**Subject: 100 Eugene St., Lots 7-A-1 & 7-A-2
Preliminary Plat Review**

The above referenced preliminary plat has been submitted and reviewed for general compliance with the requirements for development in the City of Youngsville.

PLAT OF SURVEY SHOWING A PARTITION OF LOT 7-A OF BLK 9 OF THE TOWN OF YOUNGVILLE FOR JOHN HARVEY

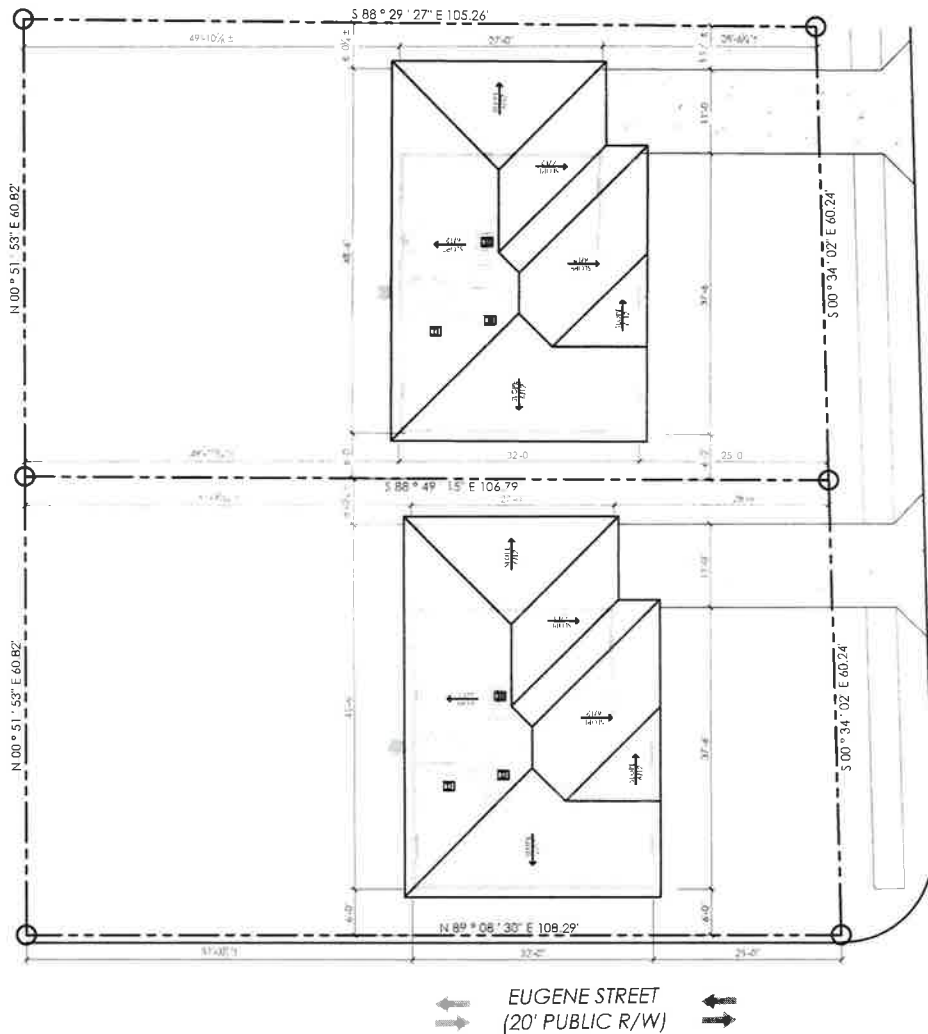
- A. Legal description needs to be shown on the plat.
- B. Plat needs to be signed & sealed by the surveyor.
- C. Addresses of Lot 7-A-1 & 7-A-2 need to be shown.
- D. The name & address of the property owner is missing.
- E. Under Site Data, add a note for the number of dwellings.
- F. A vicinity map must be included on the plat.
- G. Utility legend is missing on the plat.
- H. Under Flood Note, add a note stating, "In areas outside the SFHA, the minimum finished floor elevation must be the higher value of either 1' above the BFE or 1.5' above the road's center line elevation."
